Re: C/007/0030 Wildcat Loadout
Response to Pete Hess 11-23-2012 Letter – 3rd Quarter Coal Fines Monitoring Report at
Wildcat Loadout

Title: REVISED APPENDIX "P" & COAL FINES MONITORING

RESPONSE TO DIVISION ORDER DO-04 WIND-BLOWN FINES ACCUMULATIONS

**WILDCAT COAL FINES ISSUE
DIVISION ORDER-04(WIND BLOWN FINES)
ANNUAL MONITORING**

FIGURE 1

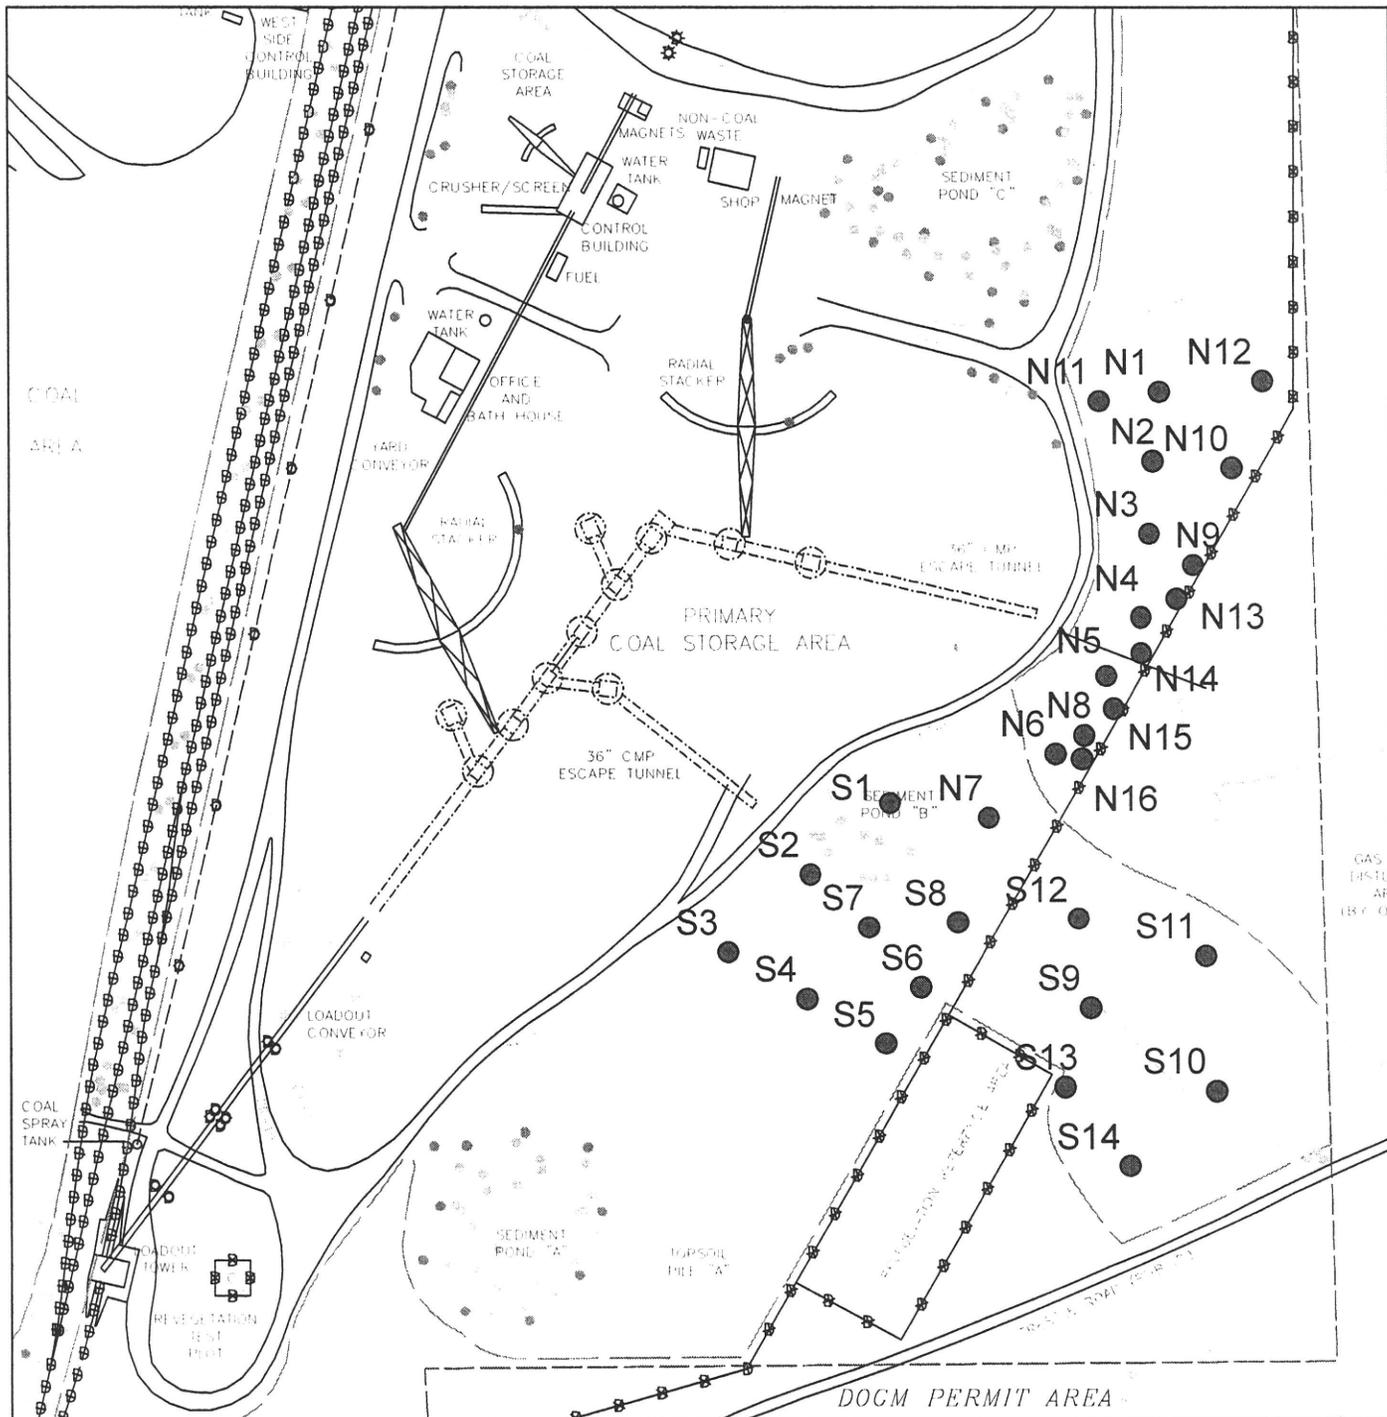
3) The Division recommends that five additional monitoring points be installed in the area west of the eastern DOGM permit boundary (four, east of monitoring points N6, N8, N5, N4, and N9, and one additional point east of N1).

Five (5) additional random points were installed as outlined above. These points along with existing points are shown on Figure 1.
